Re: Contra Costa Water District Comments on Bay Delta Conservation Plan and Draft EIR/EIS

Draft Bay Delta Conservation Plan and Accompanying
Draft Environmental Impact Report / Environmental Impact Statement

Contra Costa Water District
Comments on the December 13, 2013
Draft Bay Delta Conservation Plan and Accompanying Draft EIR/EIS

Figure 2-6. Impacts to Los Vaqueros Reservoir illustrated from modeling performed as the basis for BDCP Draft EIR/EIS.

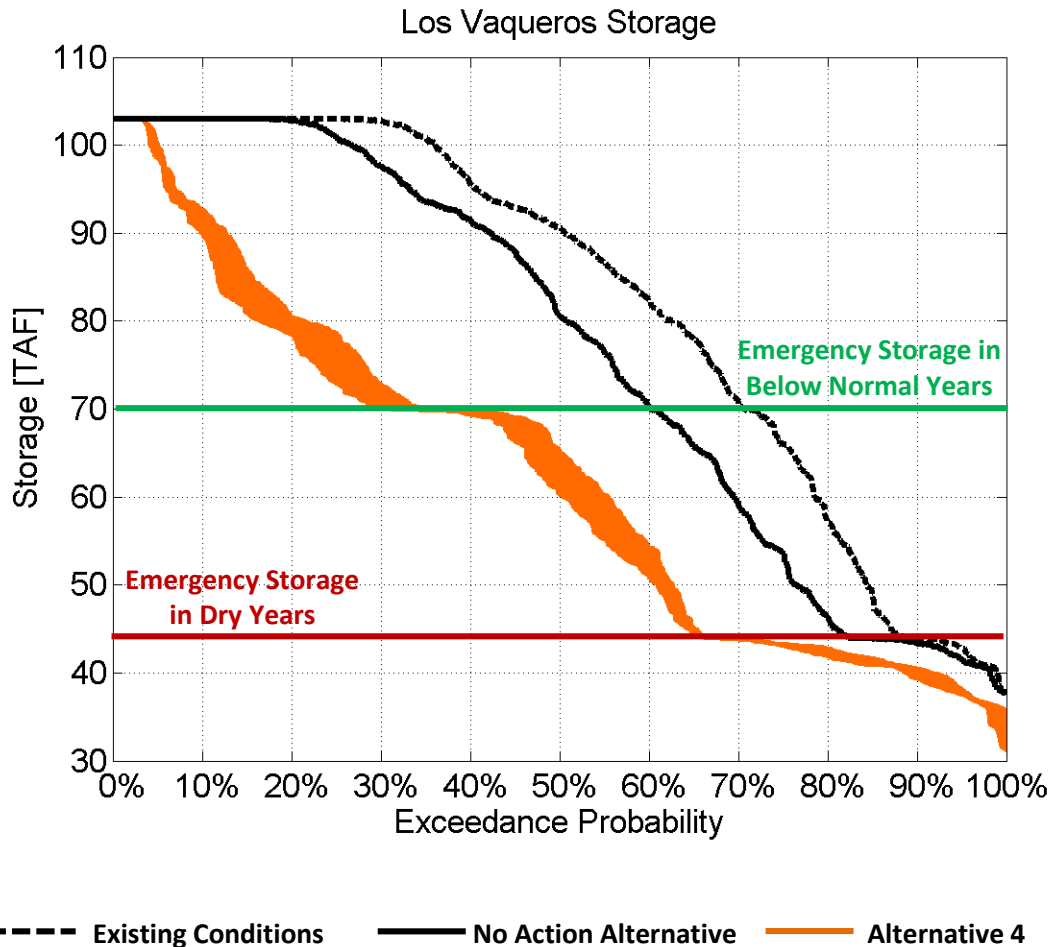
As shown in Figure 2-6, the DWR Preferred Alternative, Alternative 4, would result in significant reductions in storage in Los Vaqueros Reservoir compared to the existing conditions and the No Action Alternative. Without the BDCP, Los Vaqueros Reservoir would be at maximum storage capacity 30% of the time under existing conditions and 20% of the time under the No Action Alternative; with the DWR Preferred Alternative, Los Vaqueros Reservoir would be at maximum storage²⁵ only 4% of the time. Furthermore, without the BDCP, Los Vaqueros Reservoir would remain above the emergency storage level designated for below normal years (70 thousand acre-feet) 70% of the time under existing conditions and 60% of the time under the No Action Alternative; however, the DWR Preferred Alternative would reduce storage such that the reservoir would be above this level only 29% to 34% of the time, depending on the outcome of the BDCP "decision tree" process. The BDCP modeling clearly shows that while other future conditions that may occur without the BDCP, such as climate change and sea level rise, do have an impact on the storage in CCWD's Los Vaqueros Reservoir,²⁶ the BDCP would have a much more significant impact.²⁷

Figure 2-6 and Figure 2-7 illustrate how the DWR Preferred Alternative, Alternative 4, would impact storage in Los Vaqueros Reservoir; similar impacts would be likely to occur under all BDCP alternatives that have significant impacts on chloride concentration at CCWD's intakes, which includes all of the action alternatives. BDCP Draft EIR/EIS, Executive Summary, Table ES-9 at p. ES-64.

Figure 2-7. Impacts to Los Vaqueros Reservoir based on refined modeling, taking into account biases identified by DWR and correcting the storage capacity of Los Vaqueros Reservoir.

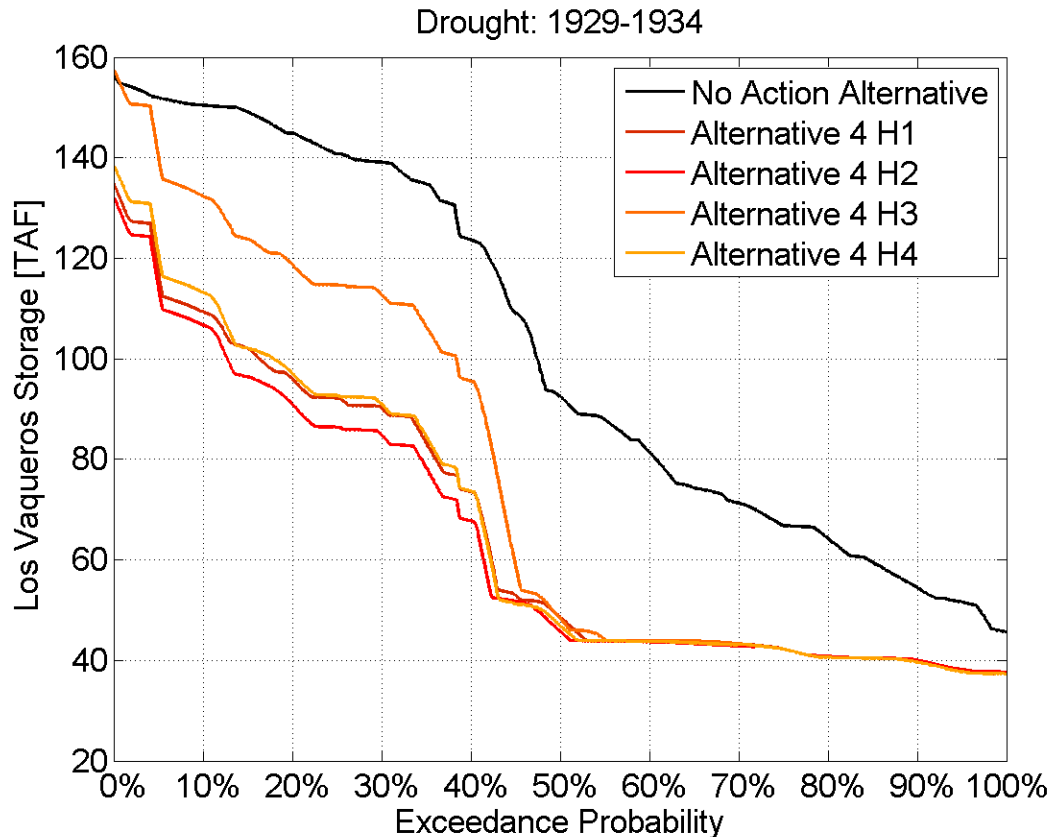
Because neither the modeling performed for the BDCP Draft EIR/EIS nor the subsequent refined modeling performed by DWR staff examined the potential effects on the Los Vaqueros Reservoir for all of the relevant time periods, nor did DWR examine the effects on the existing 160 thousand acre-foot reservoir, CCWD conducted independent modeling to examine the potential effects on its facilities. Following DWR staff's suggestions, CCWD used the Delta Simulation Model II (DSM2) to determine chloride concentration at its intakes, taking into account whether the salinity was from ocean or agricultural salt to determine the amount of chloride in the water. CCWD input this refined water quality data into a model that simulates the operation of CCWD's raw water facilities, including its Delta intakes and Los Vaqueros Reservoir at the reservoir's expanded 160 thousand acre-feet capacity. CCWD's analysis found that the BDCP Alternative 4 would have significant impacts to storage in Los Vaqueros Reservoir, with the most severe impacts occurring during droughts when CCWD water supply is most vulnerable. Figure 2-7 shows the impacts that BDCP Alternative 4 would have on storage in Los Vaqueros Reservoir during a six-year drought that is based on the historical drought from 1929 through 1934. Without the BDCP (in the No Action Alternative), reservoir storage would never reach the level designated for emergency storage in dry years (44 TAF). However, under BDCP Alternative 4, the reservoir would be at or below the emergency storage level approximately 50% of the time during drought conditions.

The volume of water in storage in Los Vaqueros Reservoir is greatly reduced by BDCP Alternative 4 for all possible outcomes of the decision tree (i.e. operational scenarios H1 through H4) during a potential six-year drought. Data source: modeling performed by CCWD following the suggestions of staff at DWR.

Figure 2-8. Percent of years when San Luis Reservoir drops below the “low point” that creates water supply and water quality impacts for certain Central Valley Project contractors

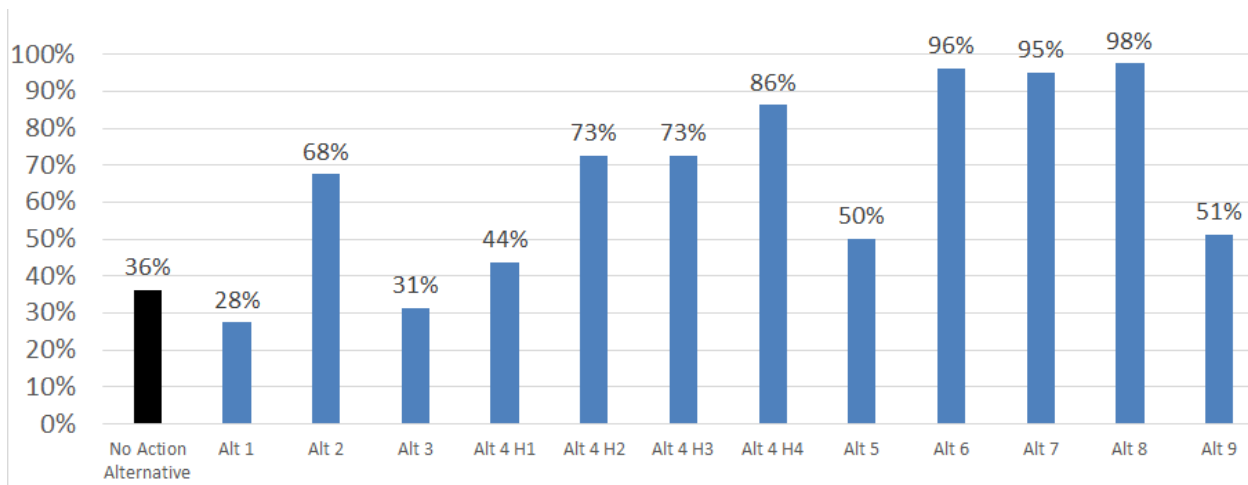
As described in Section 1.1.2, CCWD determined the percentage of time that the water level in San Luis Reservoir would drop below the “low point” by extracting relevant information from modeling that served as the basis for the BDCP Draft EIR/EIS analysis and that was provided to CCWD by DWR (DWR, 2013b). For all alternatives except for Alternatives 1 and 3, the BDCP would exacerbate the San Luis Reservoir low point problem (Figure 2-8). Under the DWR Preferred Project, Alternative 4, storage in San Luis Reservoir would drop below 300 thousand acre-feet in 44% to 86% of the years, depending on the outcome of the decision tree studies, as compared to 36% of the years under the No Action Alternative.

The BDCP would increase the percent of years that would experience impacts related to low storage levels in the San Luis Reservoir for alternatives 2, 4, 5, 6, 7, 8, and 9.

Figure 2-9. BDCP facilities (Alternative 4) with CCWD intakes and pipeline in the south Delta.

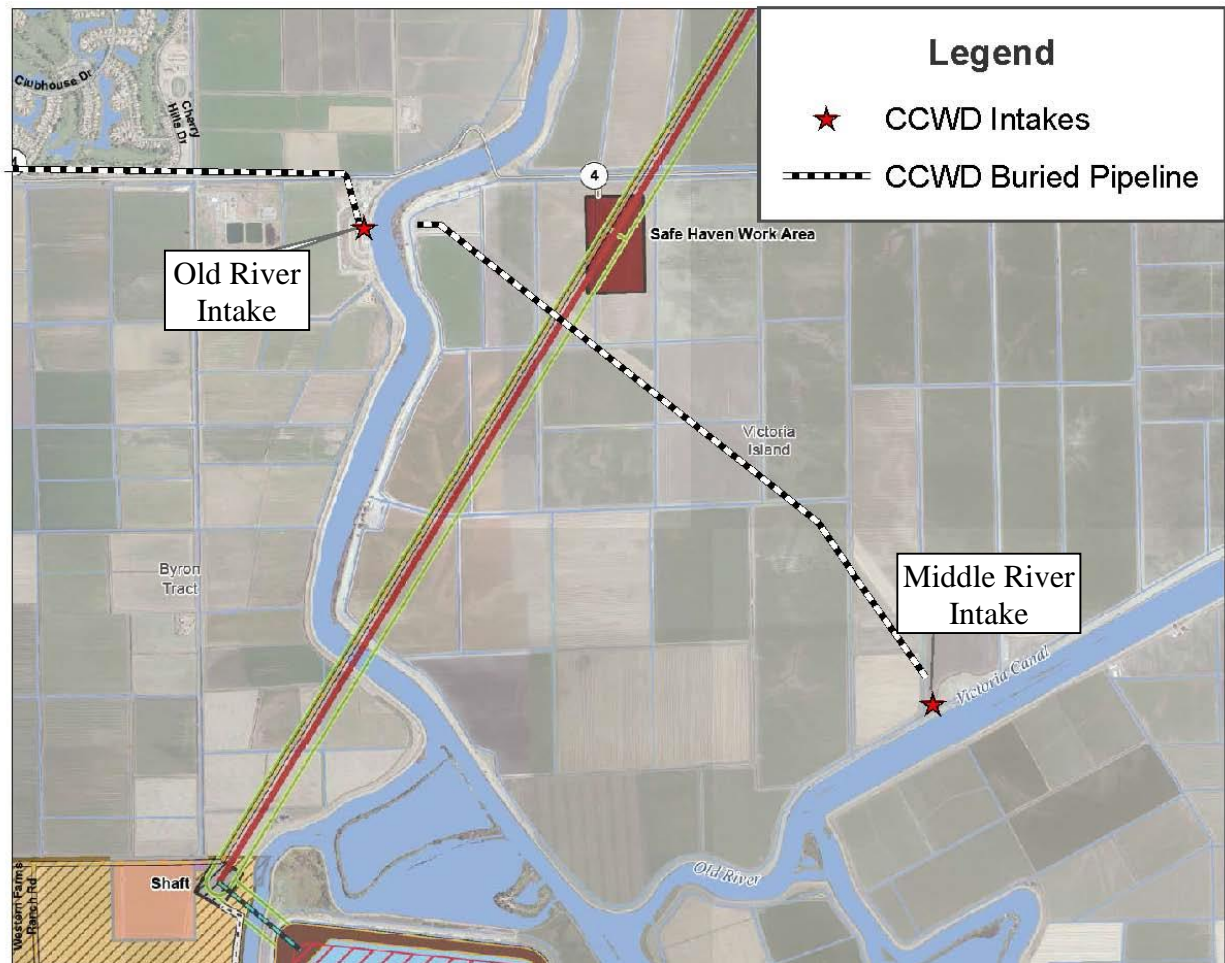
Construction of CM1 in Alternative 1A, 2A, 3, 4, 5, 6A, 7, and 8 would be likely to restrict access to CCWD's existing facilities. The tunnels would cross under the CCWD Middle River Pipeline in Victoria Island and under the Western Area Power Administration power line that was constructed for the Middle River intake. Figure 2-9 below shows CCWD's facilities superimposed on the BDCP facilities. BDCP Draft EIR/EIS, Chap. 3 Mapbook Figure M3-4 (Sheet 11 of 15), and Chap. 13, Mapbook Figure M13-4 (Sheet 6 of 8).

Construction work could interfere with CCWD's routine maintenance access to facilities along the tunnel alignment. Construction at Highway 4 may affect daily access to the Middle River intake and facilities there. Similarly, construction could impair emergency ingress and egress to the intake on the Victoria Island levee road.
